Table 1 Response to EPD's Request for Supplementary Information (Ref: EPD's letter dated 9th March 2011)

ANNEX A

Update to EIA Report Section 4.6.4 Trees within the Project Site (Figures 1 and 3)

Figure 15. T3 (*Nageia nagi*) before damage by Typhoon Fengshen, with exceptionally restricted branch development and limited crown spread. Note the two neighbour trees (T2 and T4) that competed with T3 for growth space (photos supplied by the Trust).

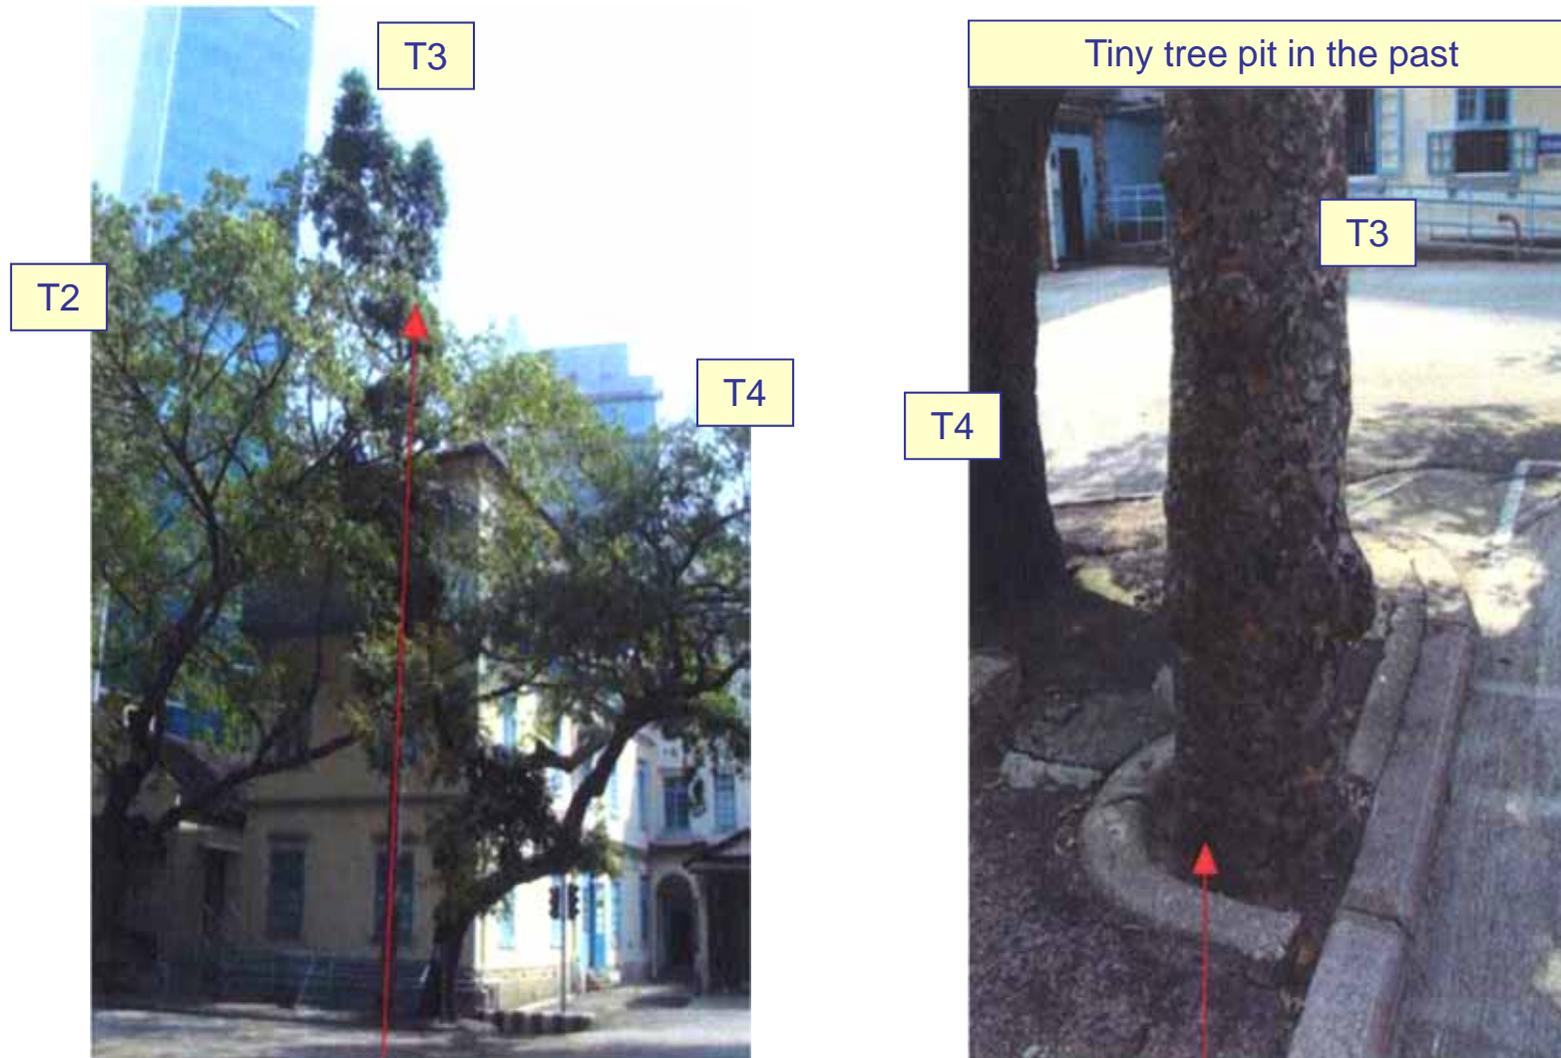
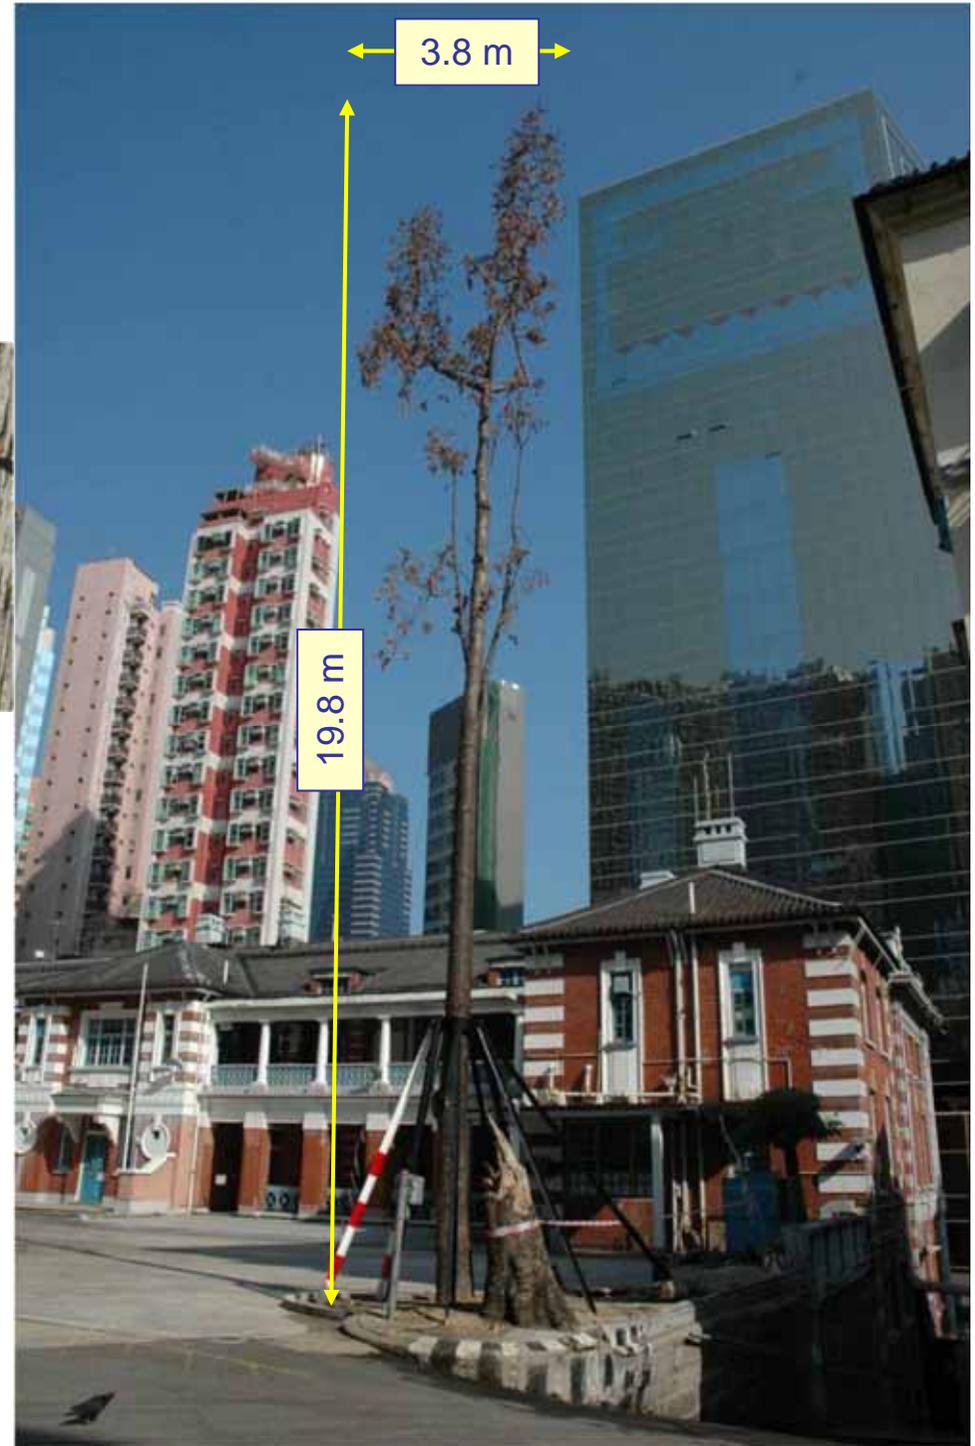
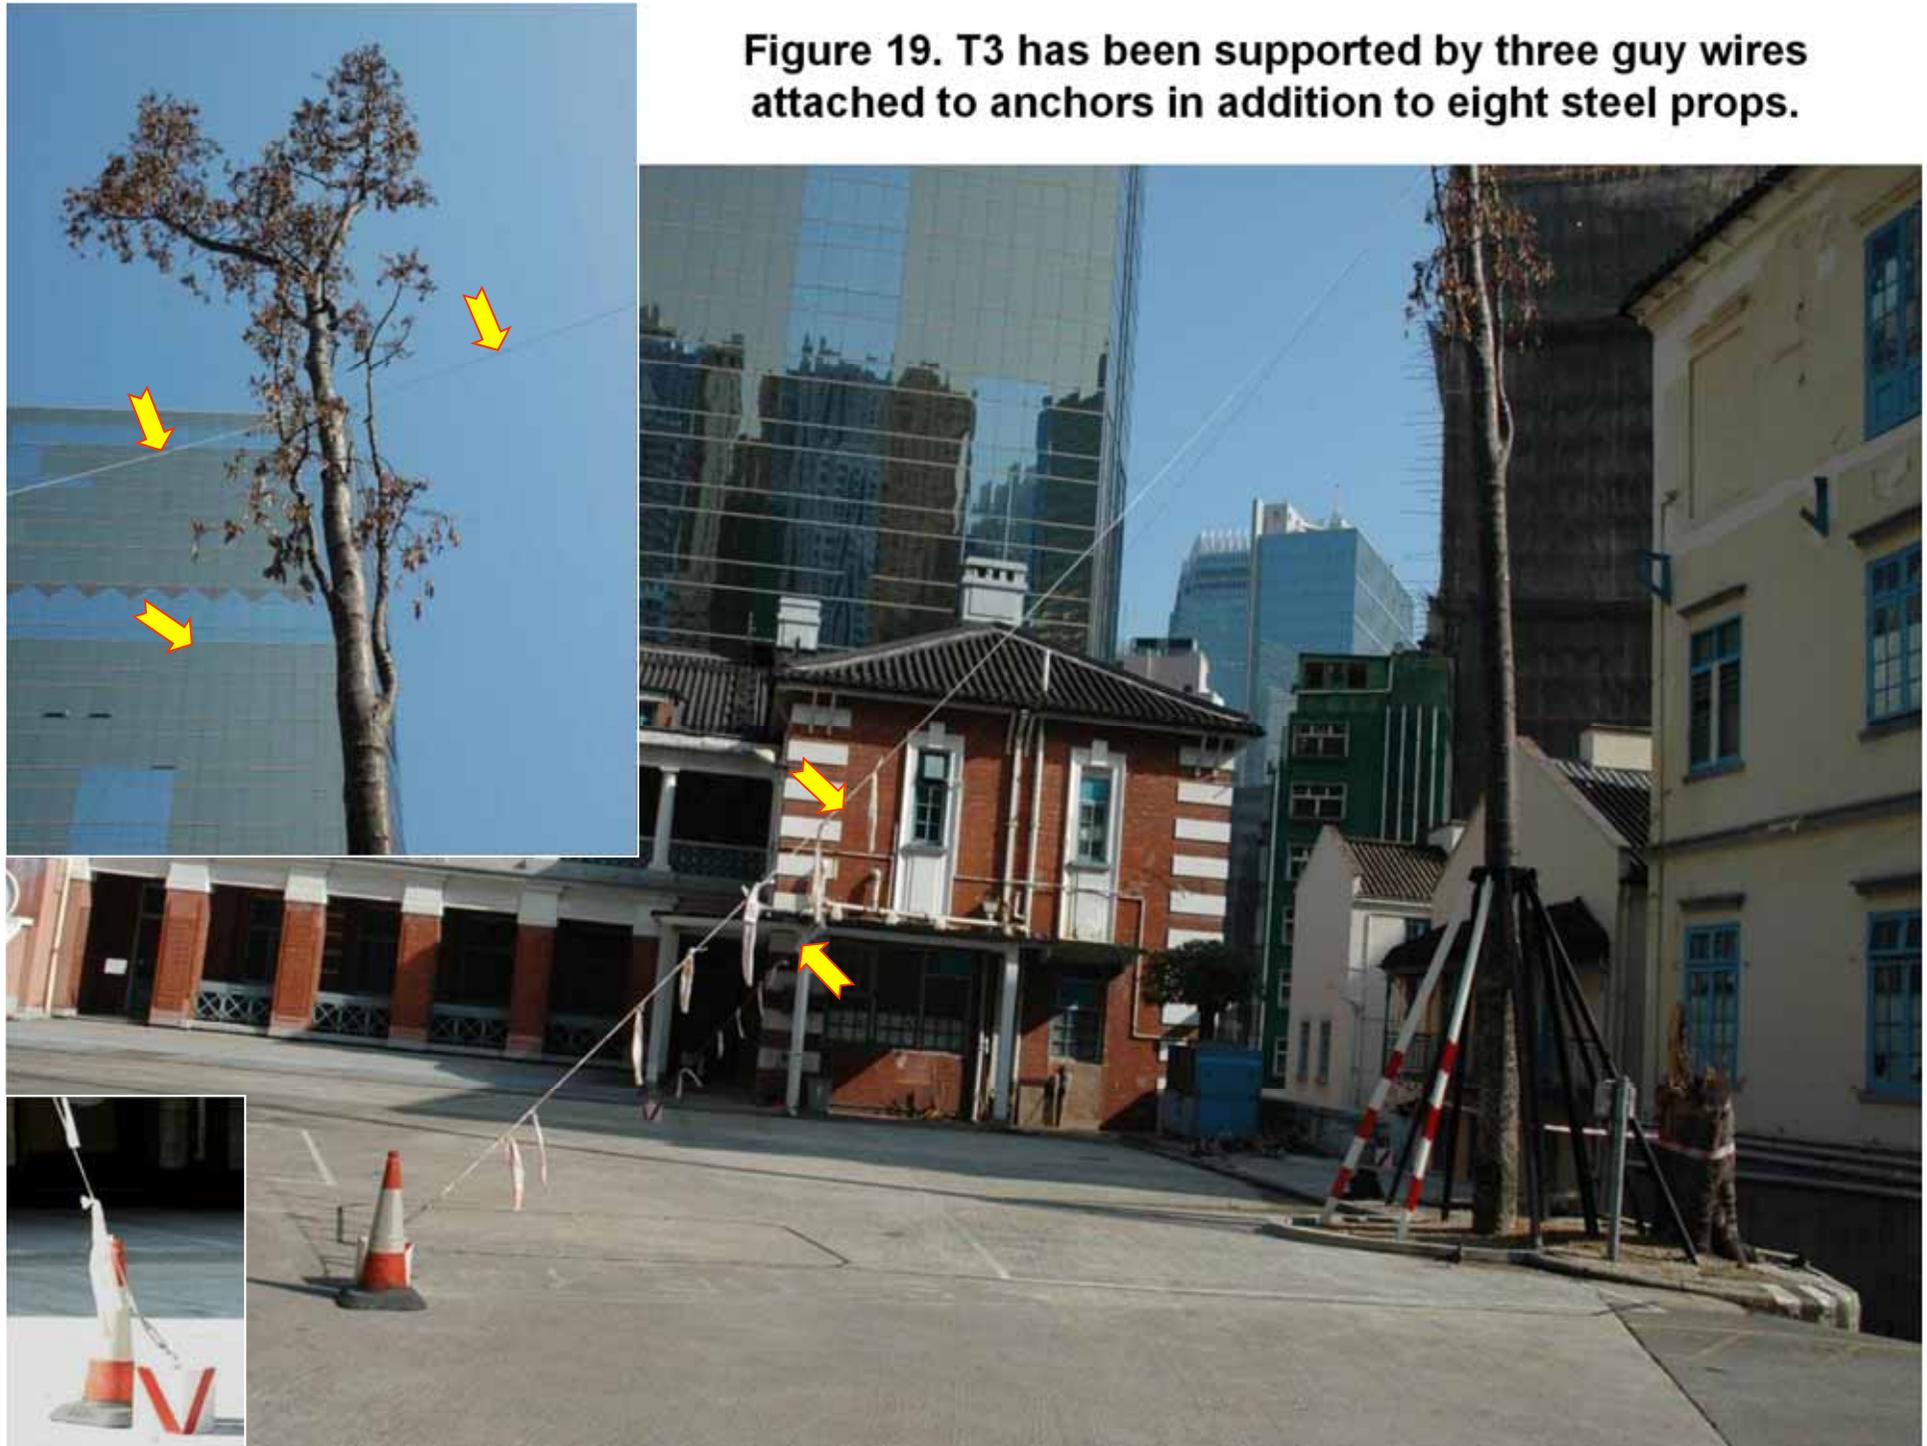
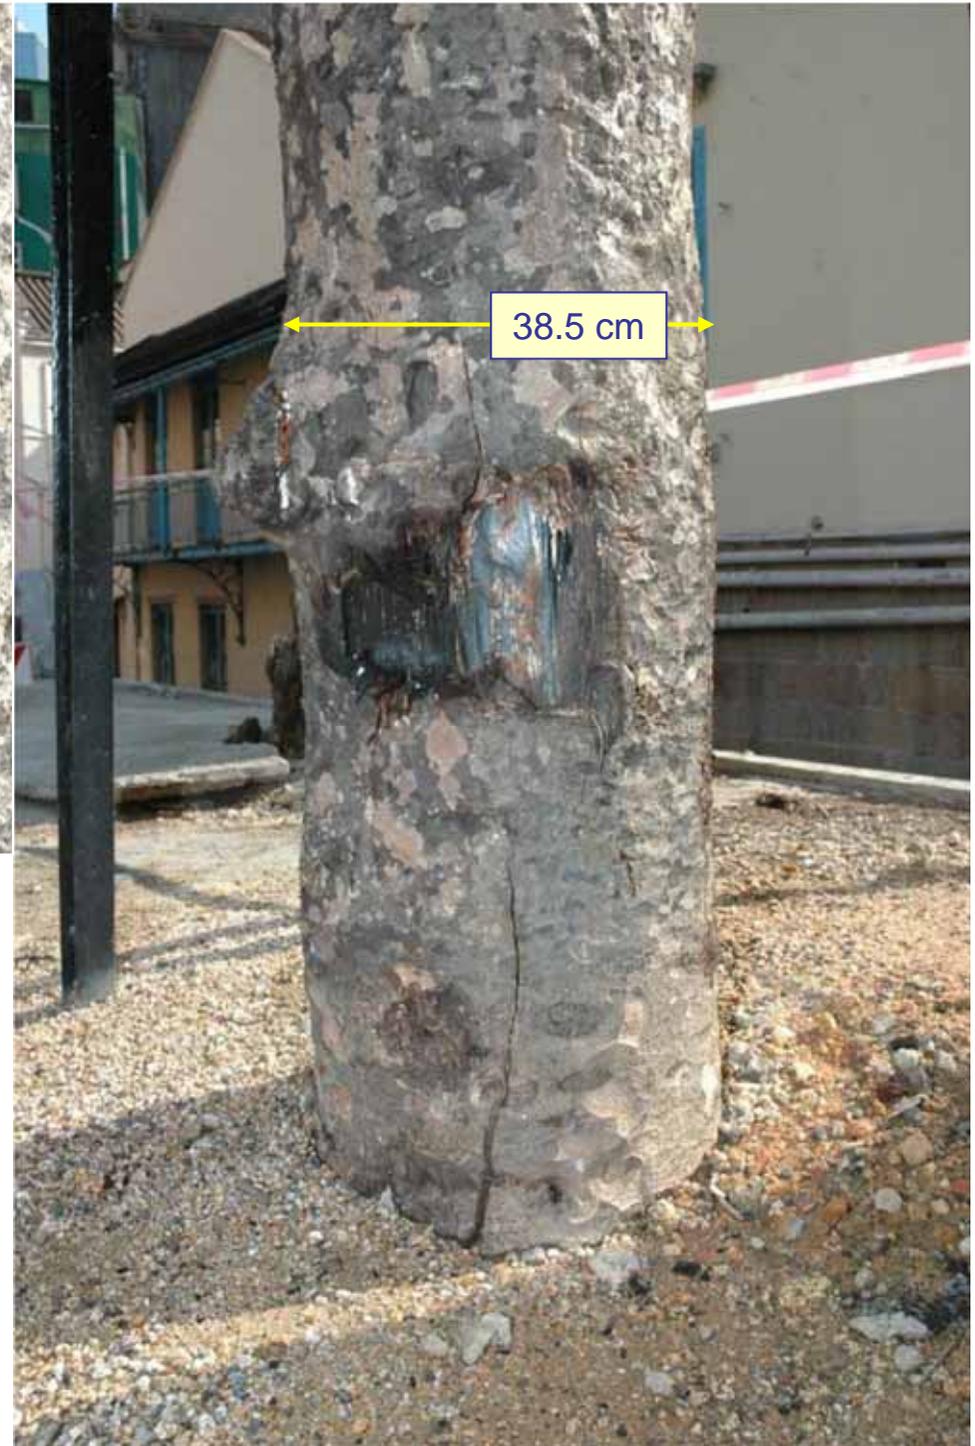
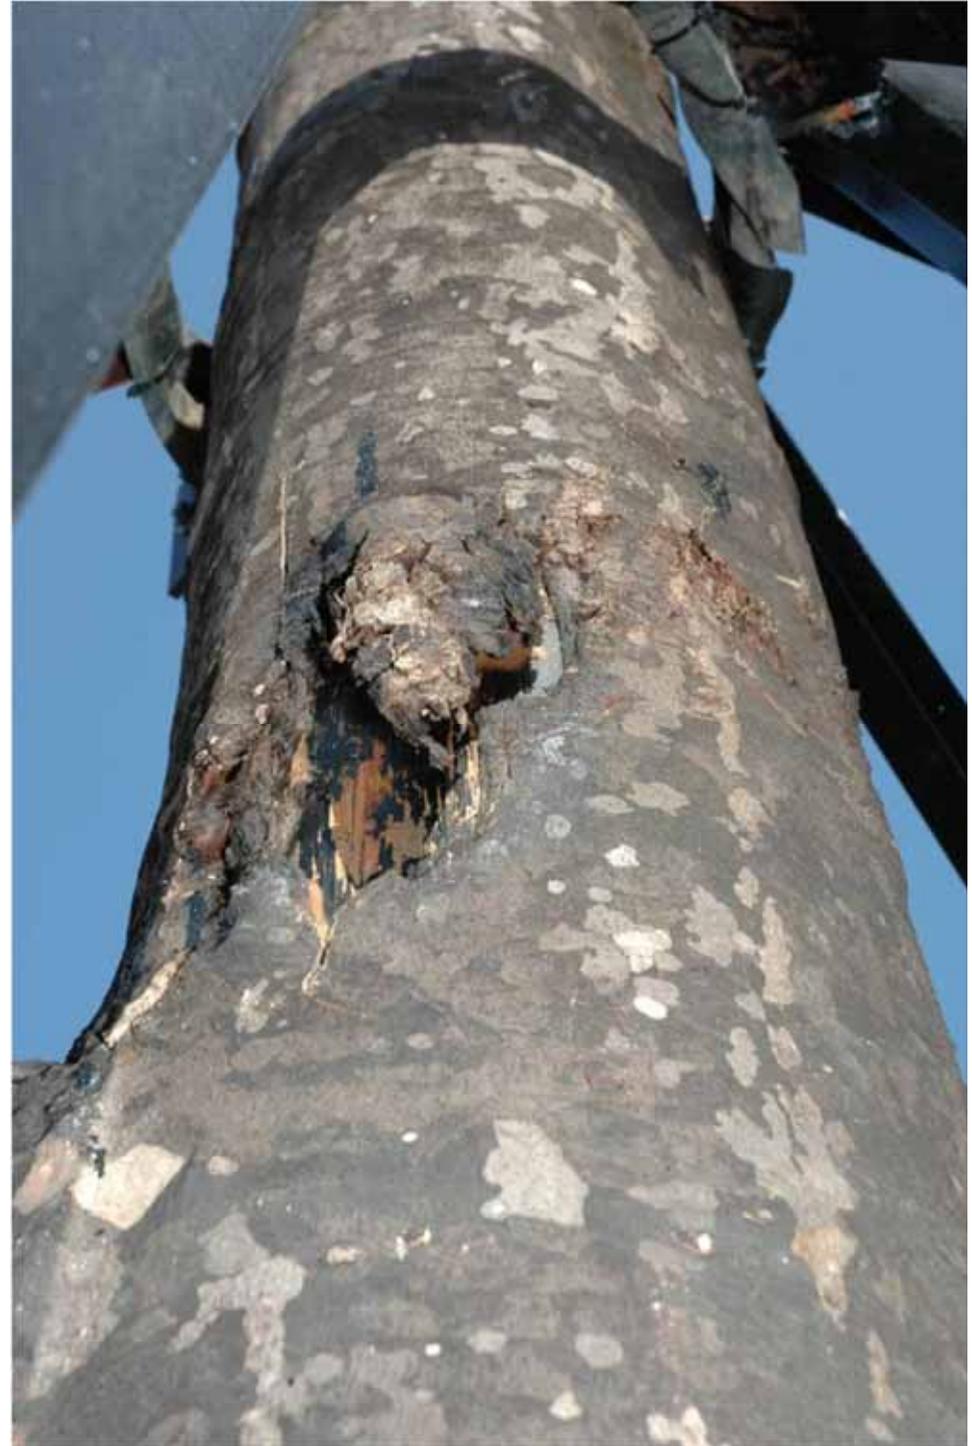
T3 – *Nageia nagi* (Figures 15 to 26)

T3 was uprooted by Typhoon Fengshen on 25 June 2008. Previously it stood 20 m tall with an exceptionally limited crown spread of merely 6 m and a trunk diameter of 40 cm and was considered to be around 60 years old. A *Nageia nagi* of similar height would have the ability to develop a crown up to 10 m across. By local standards, T3 was probably the largest and oldest specimen of the species, even though its structure was not too representative of the species at its prime. Soon after the collapse, the tree was lifted to the upright posture and supported by a propping system composed of eight inclined steel bars connected to a steel ring around the trunk. In addition, the tree was pulled by three guy wires linked to a higher position of the trunk. Upon inspection in February 2009, it was concluded that T3 had died.

T3 is now considered to be dead as a result of toppling by Typhoon Fengshen which brought massive root breakage and injuries and should be removed. Despite no compensatory planting being required, it is suggested that the entire strip of land that previously accommodated T1 to T4 should be revamped to provide a planting site with improved soil conditions for future tree growth and six trees be planted here, as detailed in CM6 of Table 4.5.
